**No. EC155-26-010**

## SERVICE BULLETIN

**FIRE PROTECTION - Engine fire detectors**  
**Check and replacement of the engine fire detectors**

### SERVICE BULLETIN No. 292 26 2882

### 2.6.1. Implementation

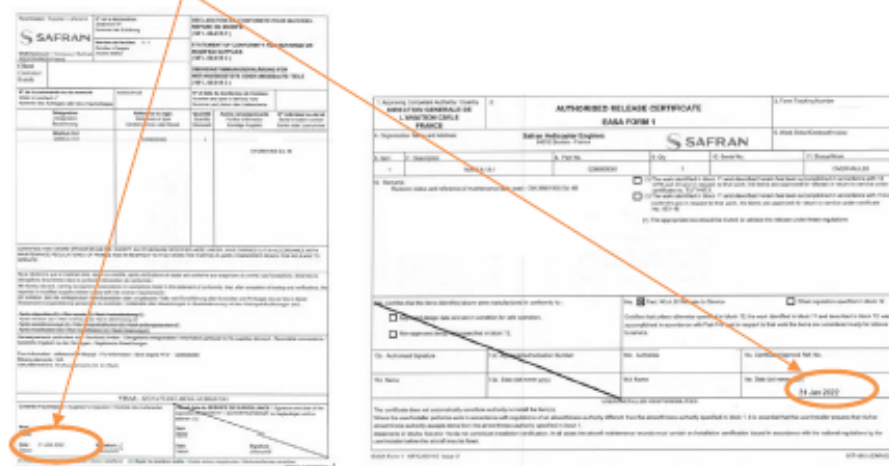
Removal of the engine can be necessary for this SB to replace the concerned fire detectors.

2.6.2.1. Do a check, as specified in paragraph 2.5, of the fire detector S/Ns given in the list in the Appendix A\* to know if they are installed on your engines.

2.6.2.1.1. If the fire detector S/Ns given in the list in the Appendix A are not installed on your engines or if they are not in stock, do not do this SB.

2.6.2.1.2. If the fire detector S/Ns given in the list in the Appendix A are installed on your engines:

- Contact your local Safran Helicopter Engines representative.
- Replace the fire detectors with compliant fire detectors: Refer to the applicable ARRIEL 2 Maintenance Manual, task 26-11-00-900-801.
- Refer to paragraph 2.6.4 for identification.
- Discard the removed fire detectors.

2.6.2.1.3. If the fire detector S/Ns given in the list in the Appendix A are in stock:

- Contact your local Safran Helicopter Engines representative.
- Discard the fire detectors.
